TECHNICAL SERVICE BULLETIN

NO. 73/H/2

Marina Air Conditioning Compressor
Pulleys

Austin Marina

Marine Air Conditioning Compressor
Pulley

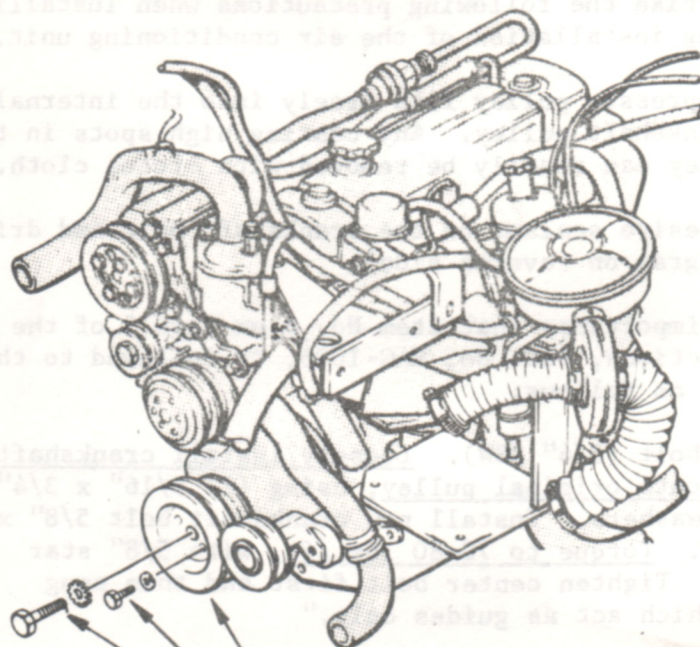
1. Insure that the compressor pulley fits freely into the internal diameter of the crankshaft pulley. Any casting high spots in the OEM crankshaft pulley can readily be removed with crocus cloth.
2. Use Loctite 242 adhesive sealant on the crankshaft bolt and driving bolts (refer to diagram on reverse side).
3. It is of paramount importance that Item No. 6 on Page 3 of the installation instructions, Part No. HAC-1005, is followed to the letter. This reads as follows:

"Remove crankshaft bolt (3/4" BSW). Loosely install crankshaft pulley (BL-300-6) onto original pulley, using (2) 5/16" x 3/4" NF bolts with lockwashers. Install new crankshaft bolt 5/8" x 1-1/2" (15/16 hex). Torque to 70-80 lbs./ft. with 5/8" star washer (supplied). Tighten center bolt first and then snug both 5/16" bolts which act as guides only."
